S E R V I C E N O T E

**8595E Spectrum Analyzer**

**Counter-Lock Assembly modification to improve marker count stability under certain conditions.**

Figure 1. A25 Counter-Lock Assembly

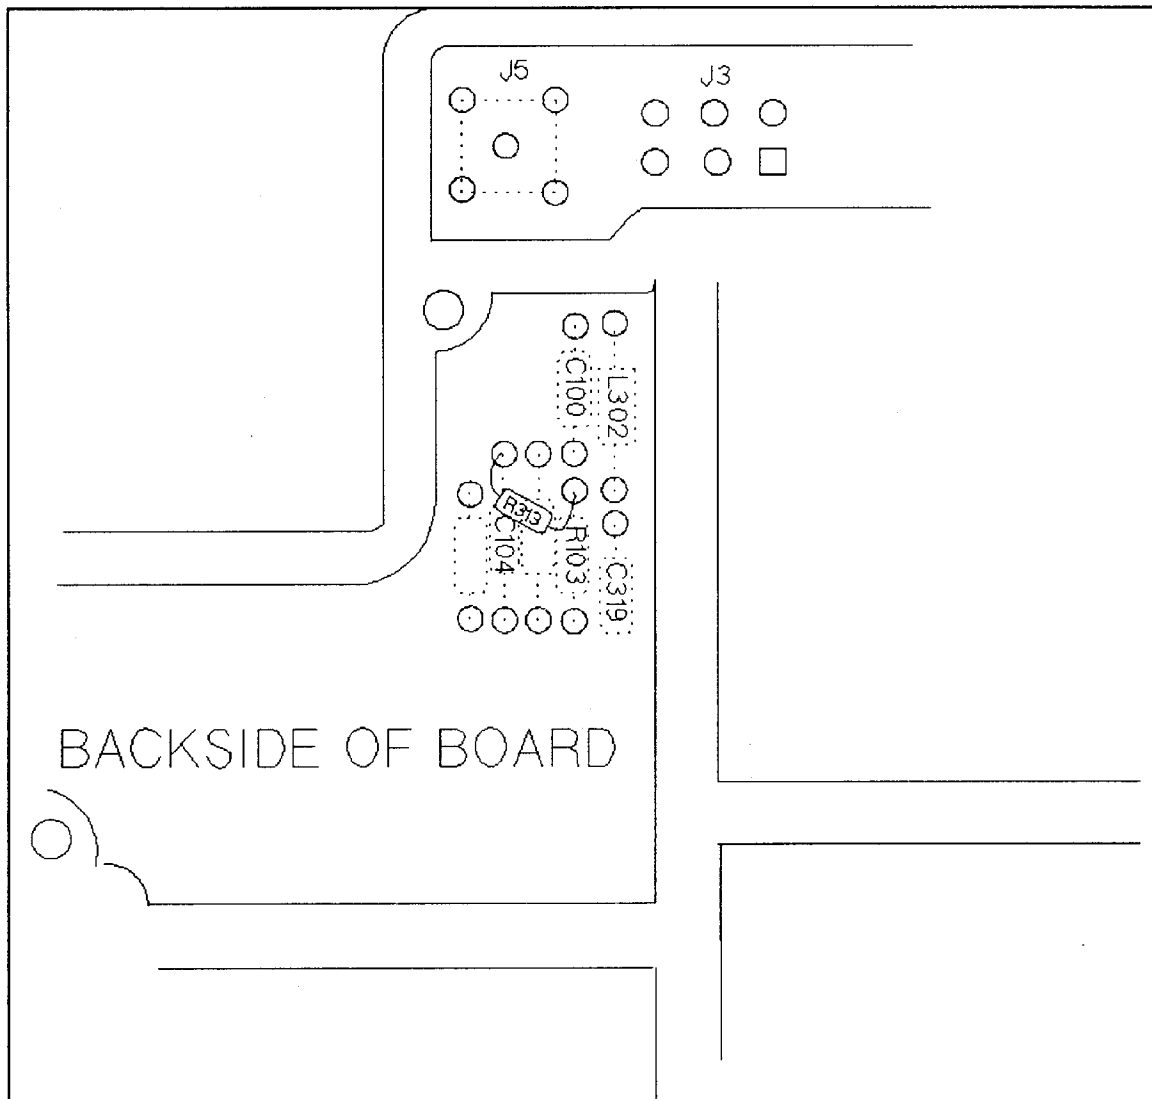
1. Reference the A25 Counter-Lock Assembly Removal procedure. The procedure is located in the section of Service Guide labeled “Replacing Major Assemblies” on pages 7-41 and 7-42.
2. Remove the screw securing the two halves of the casting. Separate the casting halves and place the assembly bottom side up on the work surface.
3. Refer to Figure 1. for the location of R103 and remove R103. Install C321 in place of R103 but do not solder at this time. Install R313 as shown in Figure 1. One lead will share a hole with C321 (just installed). The other lead will share a hole with C104 as shown.
4. Apply the label (08591-60073) over the old board number.
5. Apply a label (08591-60073) onto the rear panel for future reference.

Add a high-pass filter circuit (corner freq of 1.4MHz) to the COUNT IF1(Block M) circuit which blocks the unwanted low frequency modulation signal and allows the 21.4MHz to pass through with very little loss.
